Proposal #35: 1550-04-79
C Cumberland, Superior Avenue
Beaver Dam Lake B-03-0214
USH 63
Barron County

This is Addendum No. 01, which provides for the following:

ADDENDUM NO. 01

1550-04-79

Addendum No. 01
ID 1550-04-79
Revised Sheet 211
February 4, 2026

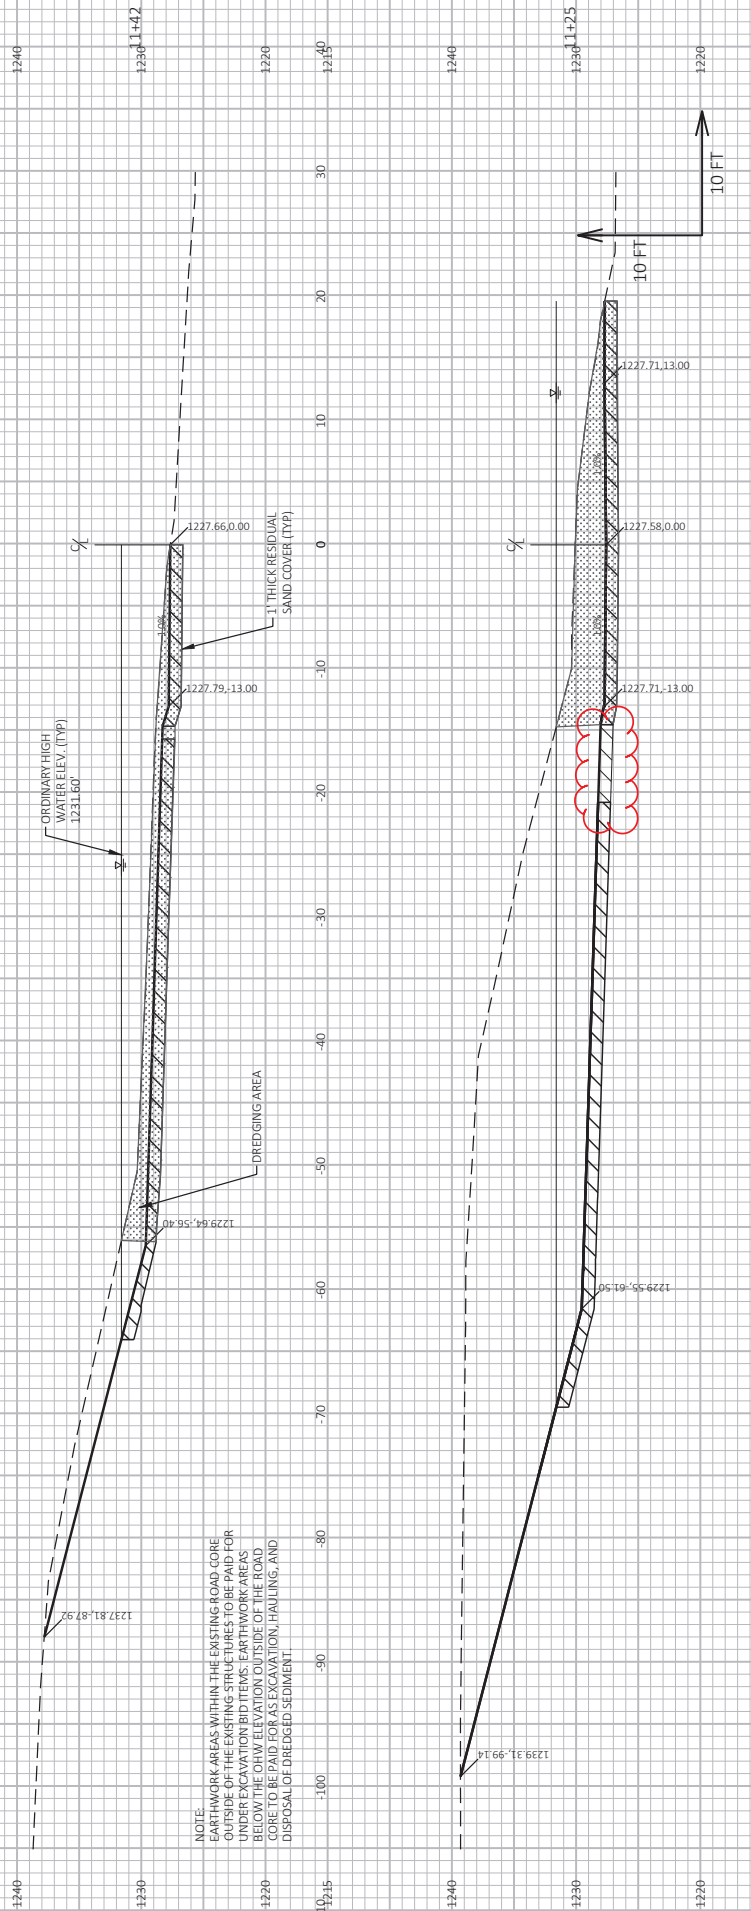
Revised Plan Sheets	
Plan Sheet	Plan Sheet Title (brief description of changes to sheet)
15	Dredging Plan View (Updated note in bottom left corner to include dredge staging information)
16	Dredging Profile View (revised sand layer note)
43	Miscellaneous Quantities (revised item names in culvert items table)
44	Miscellaneous Quantities (revised item names in storm sewer pipe items table)
50	Plan and Profile: USH 63 (revised culvert pipe item note in plan view and profile view)
52	Plan and Profile: Nedvidek Street (revised culvert pipe item note in plan view and profile view)
196	Cross Sections: USH 63 (revised culvert pipe item note in section view)
201	Cross Sections: Lake Street Removal (fixed water surface display and added proposed sloped riprap)
211	Cross Sections: Dredging (fixed gap in residual sand cover)
